UNITED STATES PATENT AND TRADEMARK OFFICE

APPLICATION NO.	FILING DATE	FIRST NAMED INVENTOR	ATTORNEY DOCKET NO.	CONFIRMATION NO.
10/604,582	07/31/2003	Laurens Wolters	71358-0052	1581
20915	7590	02/03/2006	EXAMINER	
MCGARRY BAIR PC 171 MONROE AVENUE, N.W. SUITE 600 GRAND RAPIDS, MI 49503			PHAN, THIEM D	
			ART UNIT	PAPER NUMBER
			3729

Office Action Summary

DETAILED ACTION

FIG. 2A

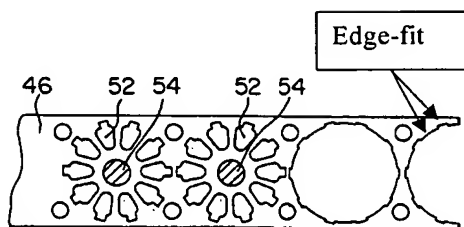
As applied to claim 12, Kaano teaches a method of manufacturing laminated core, comprising:

- providing a hollow cylindrical jig (Fig. 2B, 74) having at least one guide or edge-fit (Fig.

2A, see below) to fit the lamination;

- providing plates or laminations (Fig. 3B, 42), each having a central opening, radial poles with caps at the end of each pole, and having a guide or edge-fit (Fig. 2A, see below) corresponding in shape to mate with the at least one guide in the jig;
- providing a stop (Fig. 2B, below 42) in a jig;
- sliding each plate (Fig. 2B, 42) in the jig with the guide in the plate mating with the guide in the jig, and with the first plate bearing against the stop until a plurality of plates are disposed in the jig;
- pressing a shaft into the central openings (Fig. 3C, 44).

As applied to claim 13, Kanno teaches that the guide or edge-fit (Fig. 2A, see above) in the jig (Fig. 2B, 74) is an axial rib and the guide in each plate is a notch.
